Access Compliance Report

(Curb Ramps)

Intersection ID: 51379	Main Street: BROADRICK_BV	Cross Street: UNIVERSITY_CITY_BV	Location: S
ADA ID: 71A5ED10FB4A	Ramp Type: Perp	Initial Pass/Fail: Fail	Overall Compliance: No
Severity Score: 25			
Codes/Mitigation Info/Possible Solution		Field Measurements/Component Compliance

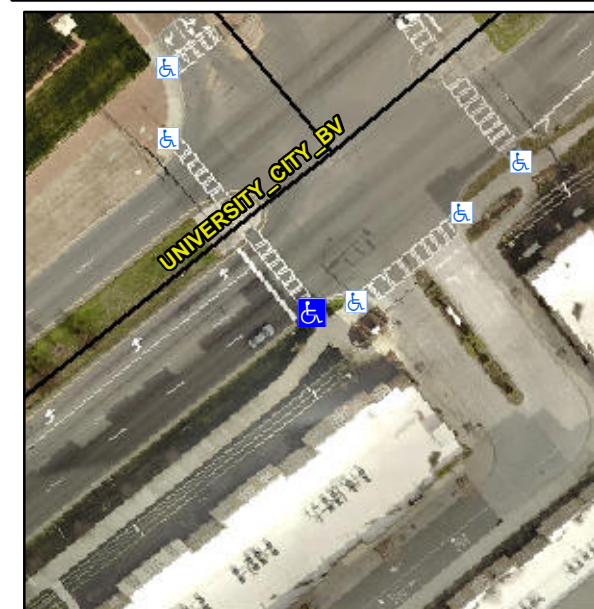
Not Found, R304.2.2

Compliance	Description	Data	Compliance	Description	Data
N/A	Ramp Length (in)	85.0	No	Ramp Slope (%)	17.1
Yes	Ramp Width (in)	93.5	Yes	Ramp XSlope (%)	1.6
N/A	Flare Type LT	N/A	N/A	Flare Type RT	N/A
N/A	Flare Slope LT (%)	N/A	N/A	Flare Slope RT (%)	N/A
N/A	Flare Traversable LT?	N/A	N/A	Flare Traversable RT?	N/A
N/A	Landing Length (in)	N/A	N/A	DWS Provided?	N/A
N/A	Landing Width (in)	N/A	N/A	DWS Contrast?	N/A
N/A	Landing Slope (%)	N/A	N/A	DWS Length (in)	N/A
N/A	Landing X Slope (%)	N/A	N/A	DWS Full Width?	N/A
N/A	Landing Curb? (Y/N)	N/A	N/A	DWS Offset (in)	N/A
N/A	Shared Landing?	N/A			
N/A	Gutter Ponding?	N/A	N/A	Gutter Slope (%)	N/A
N/A	Gutter Lip Ht (in)	N/A	N/A	Gutter X Slope (%)	N/A
N/A	Painted X Walk1?	Yes	N/A	Painted X Walk2?	N/A
	X Walk 1 Direction	To NW		X Walk 2 Direction	N/A
N/A	X Walk 1 Width (in)	79.0	N/A	X Walk 2 Width (in)	N/A
	X Walk 1 Slope (%)	3.8		X Walk 2 Slope (%)	N/A
	X Walk 1 X Slope (%)	4.0		X Walk 2 X Slope (%)	N/A

Remove & Replace Entire Ramp.
